SERIAL No.: 09/992,328

TITLE: "Drinking Container"

**PETITION TO (1) WITHDRAW RESTRICTION REQUIREMENT; (2)
REQUIRE REINSTATEMENT OF CLAIMS 2, 3, 6 AND 8-10 BASED ON THE
SUFFICIENCY OF THE DRAWINGS; AND (3) WITHDRAW NEW MATTER
REJECTIONS RELATED TO DRAWING AMENDMENTS AND TO REQUIRE
ENTRY OF APPLICANT'S FORMAL DRAWINGS**

FIG. 1C

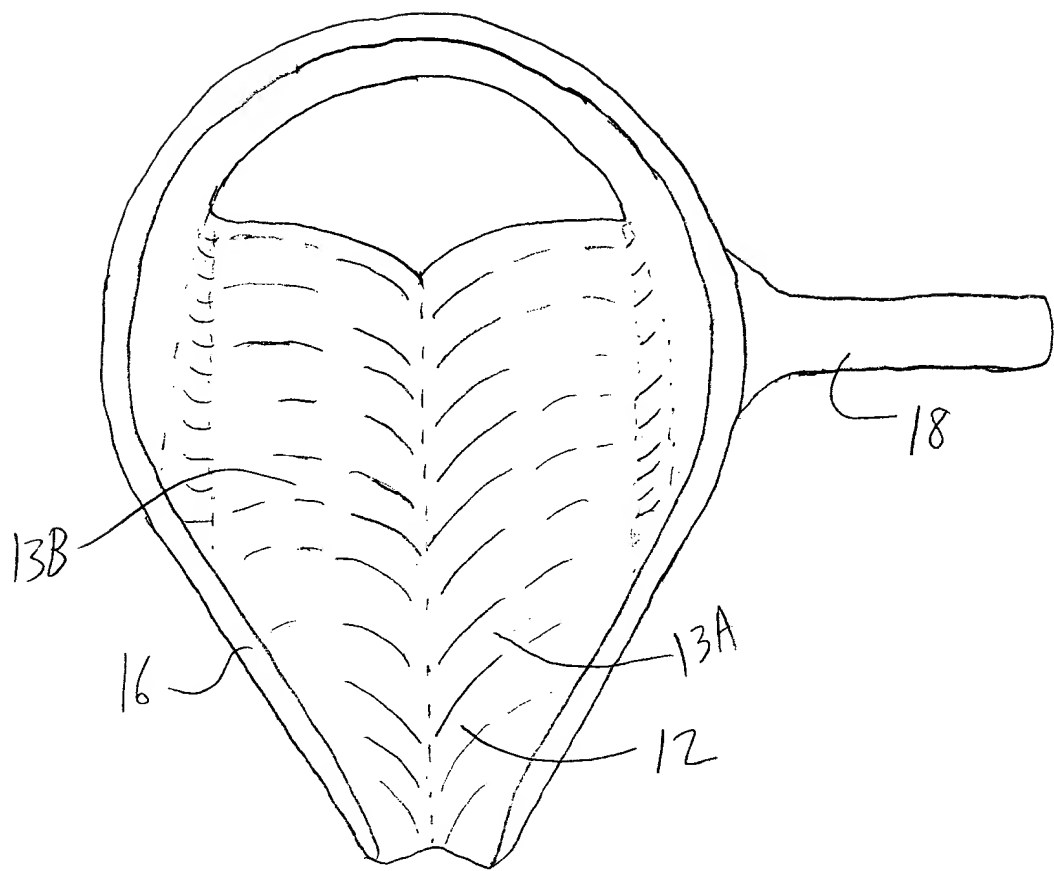
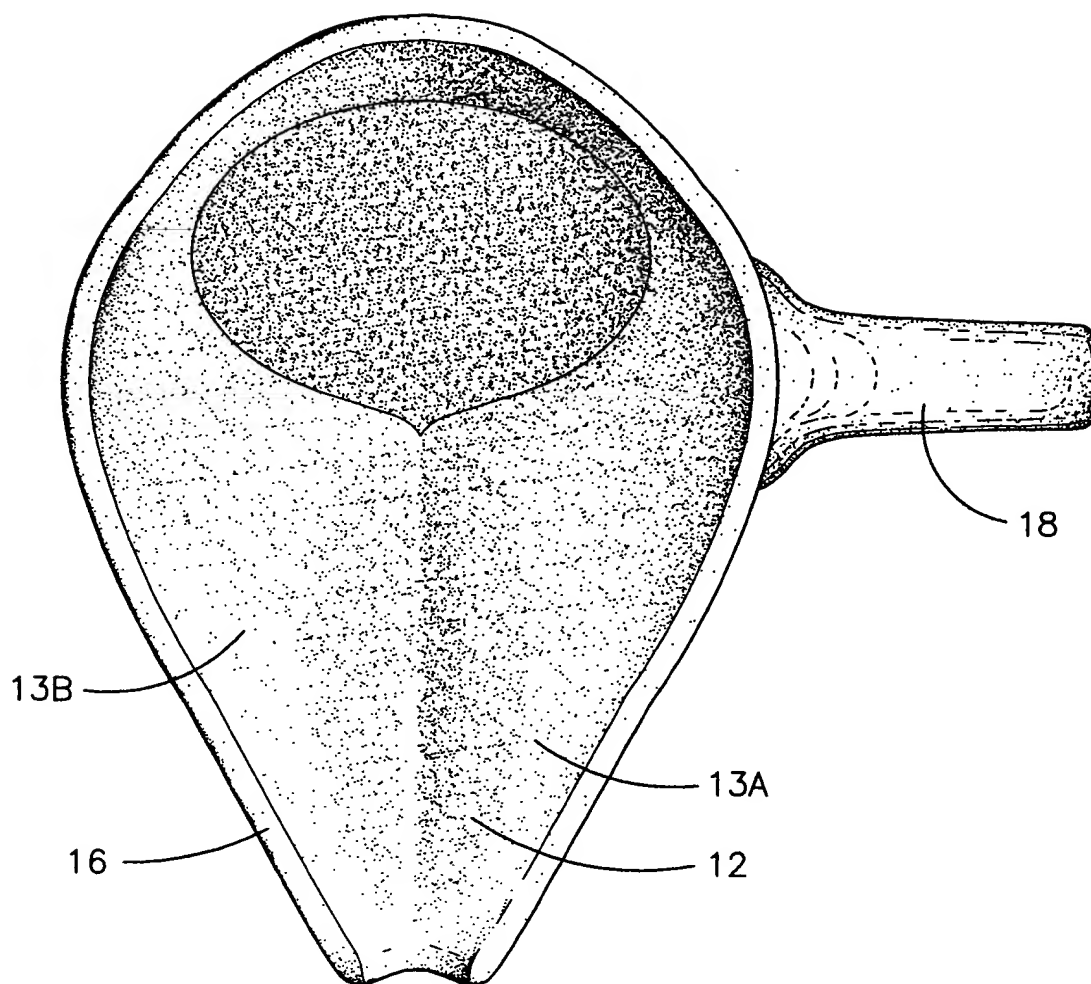
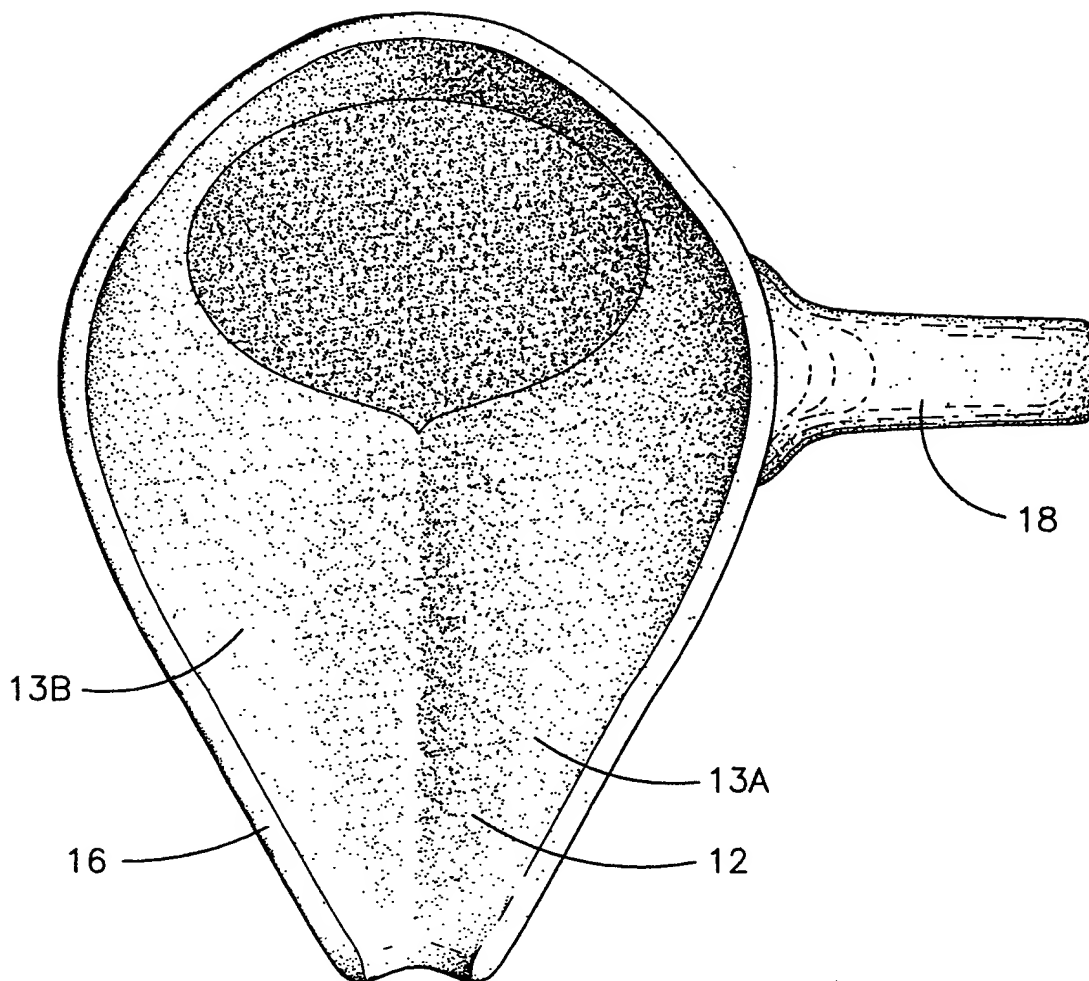
"do not show an extension spout extending upward and outward from the upper rim as claimed in claims 6 and 8-10 where the upper rim has an opening through at least a sipping region."	These items are clearly shown in Figures 1A, 1B, 1C, 2A, and 2B. The relationship and location of these items are described at page 10, lines 6-10: "The drinking container shown in Figure 1 includes an extension spout 8 extending upward and outward from the upper rim 16. The sipping region 16A is formed on the upper end of the extension spout 8. As shown in Figure 1, the extension spout 8 is contiguous with the fluid diverter member 4 to thereby assist the fluid diverter member 4 in compelling fluid through the sipping region 16A."
"The drawings are objected to under 37 CFR 1.83(a). The drawings must show every feature of the invention specified in the claims. Therefore, the flow channel extending lengthwise along an outer surface of the fluid diverter member as stated in claims 3 and 8-10 must be shown or the feature(s) canceled from the claims."	For the reasons set forth above, the flow channel is clearly shown in the drawings.

the showing of a different shaped handle as shown in Fig. 1A and 1B,” “	Figures 1A and 1B are not significantly different from the original draft drawing Figures 1A and 1C. Any differences are not patentable distinctions; they are merely minor design modifications that were made by the professional draftsman who applicant hired to prepare his formal drawings.
“a differently shaped bottom as shown in Fig. 1C,”	The bottom of the cup shown in formal drawing Figure 1C is not significantly different from the original draft drawing Figure 1C. Any differences are not patentable distinctions; they are merely minor changes in shape and proportion that were made by the professional draftsman who applicant hired to prepare his formal drawings.
“different creases as shown on the interior of the fluid diverter, flow channel and spout in Figure 2B and as shown on the exterior of Fig. 2A near spout 8, etc.”	<p>The items shown in applicant’s original draft drawings are not “creases.” They are representative markings that were intended to indicate the curvature or contour of the flow channel 12. The professional draftsman who prepared applicant’s formal drawings replaced the contour lines of the original drawing with stippling, a technique that is widely used to show contours in patent drawings.</p> <p>This curvature is clearly described in the specification at page 10, lines 4-5: “In the preferred embodiment shown in Figure 1C, the flow channel comprises a lengthwise groove formed by a pair of curved walls.”</p>

Fig. 2B

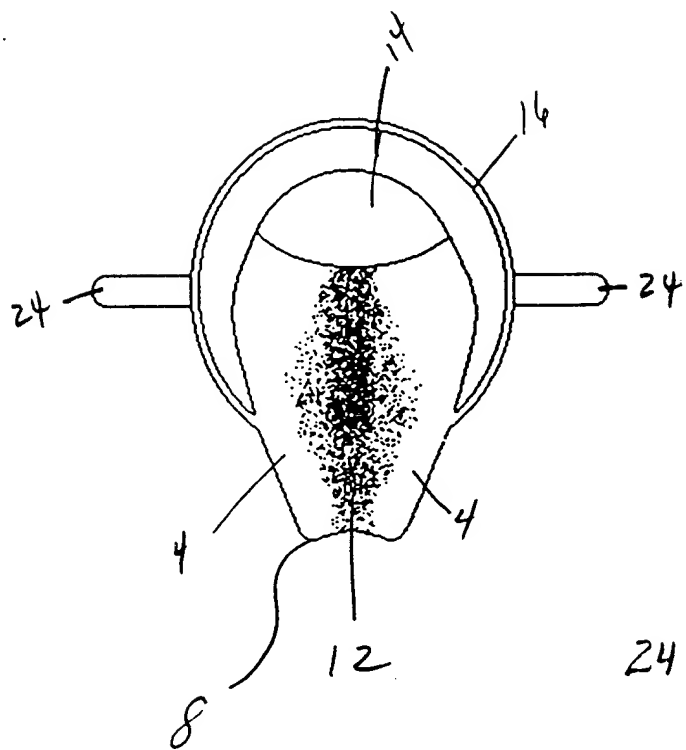
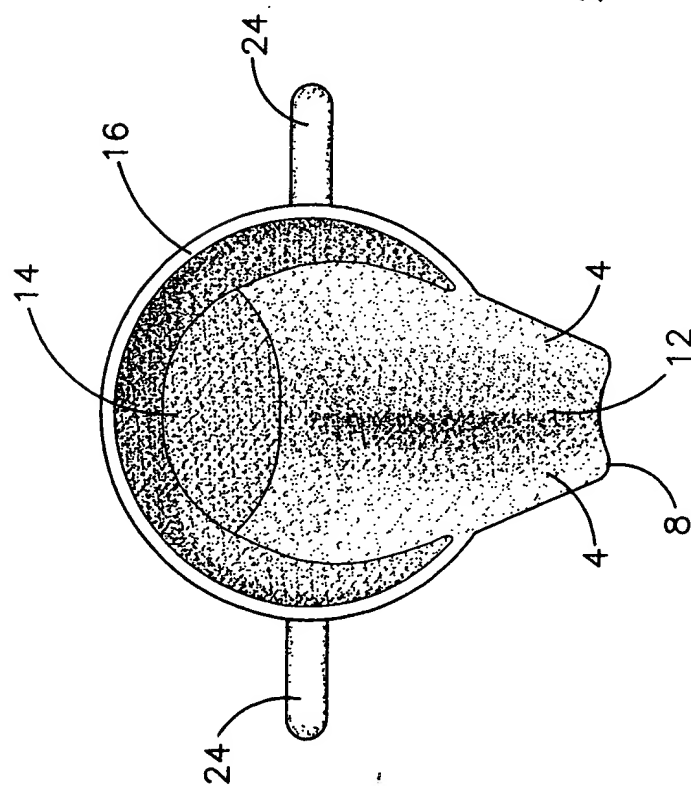
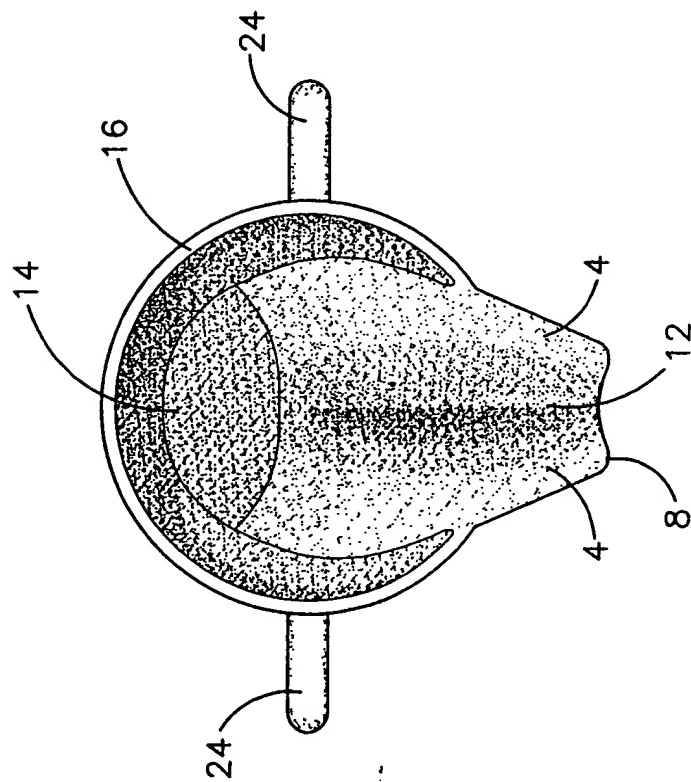
Examiner's statement concerning applicant's drawings	Applicant's response
"The fluid diverter 4, flow channel 12 and spout 8 are all located on substantially the same surface and these elements have no specific delineation to separate these elements as shown in Fig 2B."	Patent drawings routinely include a main component (here, the fluid diverter 4) that has subcomponents formed thereon (here, the flow channel 12 and the spout 8). The relationship of these three components to one another is clearly described at page 9, line 16 – page 10, line 10 of the specification. Applicant does not understand the basis of this objection, nor how it would be possible to comply with it.
"The elected specie of Fig. 2A and 2B do not show a wedge shaped fluid diverter as claimed in claims 2 and 8-10 . . ."	<p>The wedge shaped configuration of the fluid diverter member is shown in the cross-section view of Figure 1A. See specification p. 8, lines 14-15; see also Figures 3A and 4A. The top view shown in Figure 2B includes a fluid diverter member 4 that is wedge shaped.</p> <p>If the examiner is taking the position that due to applicant's election, figures other than Figs. 2A and 2B cannot be relied upon as showing claimed features,</p>

FIG. 1A

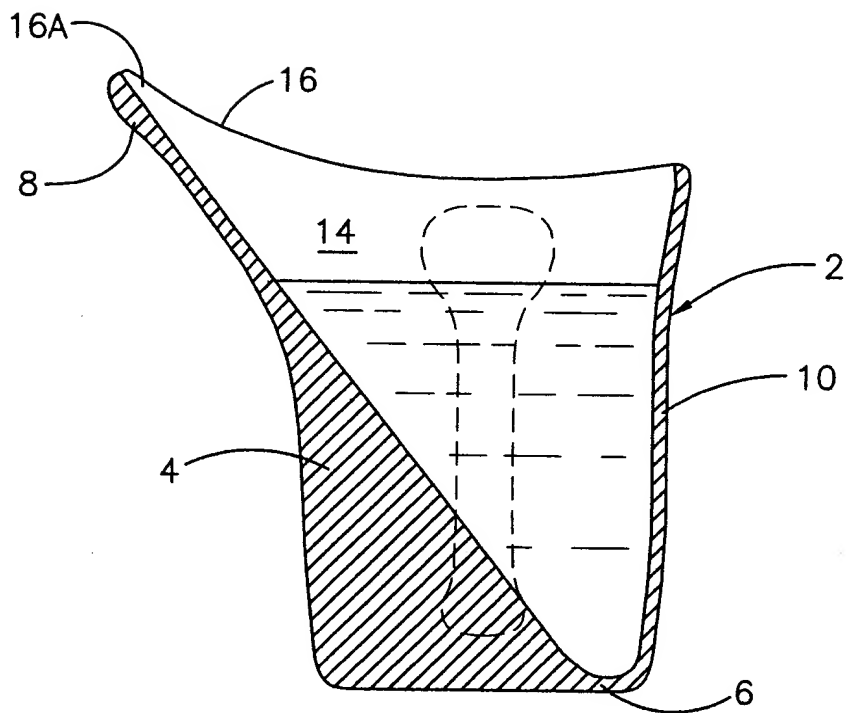
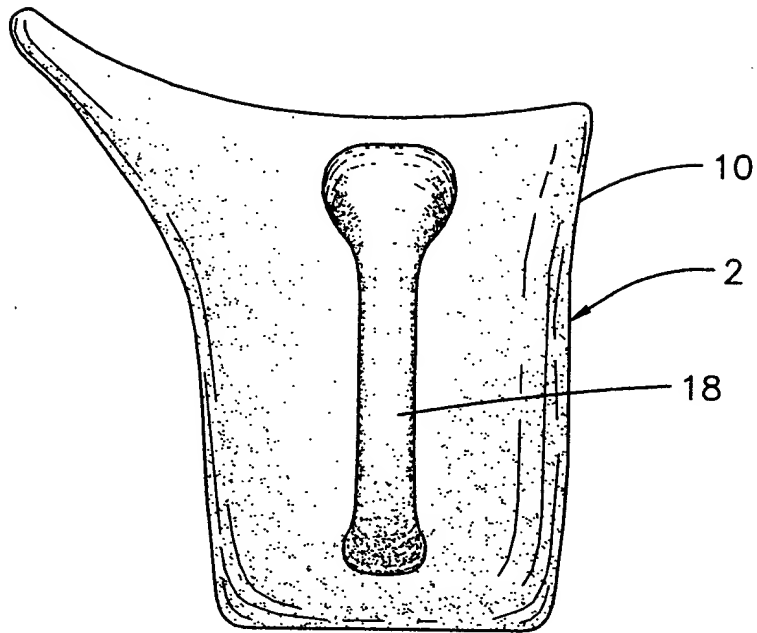
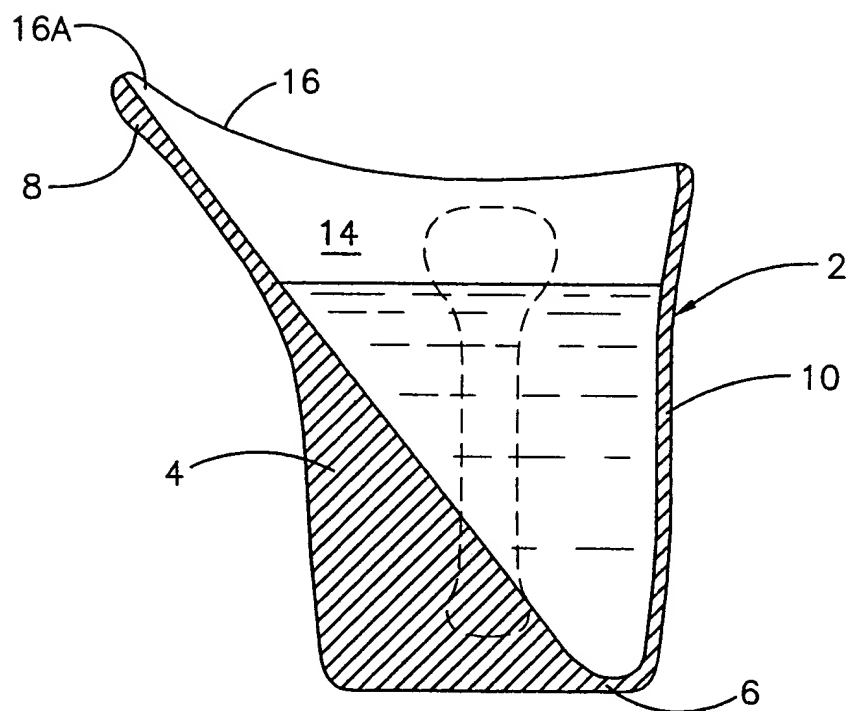
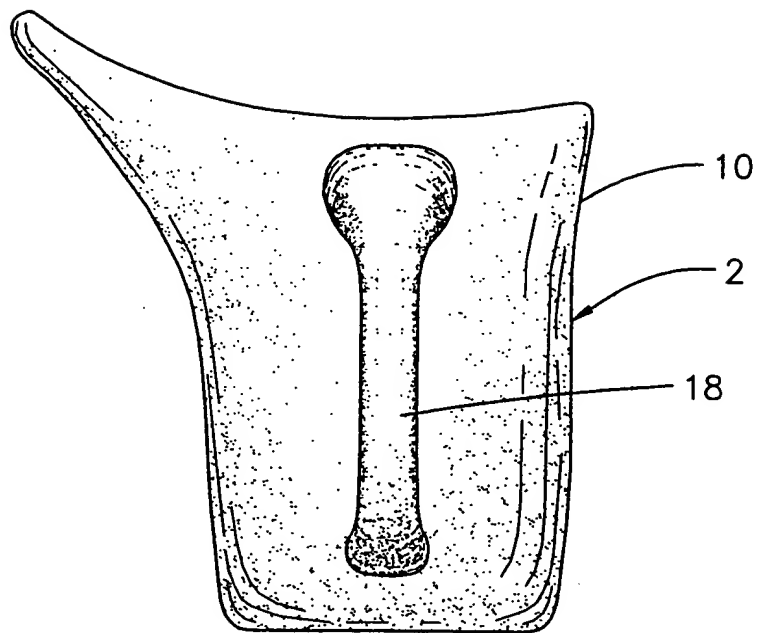
Examiner's statement	Applicant's response
"The original disclosure does not support	The handles shown in formal drawing
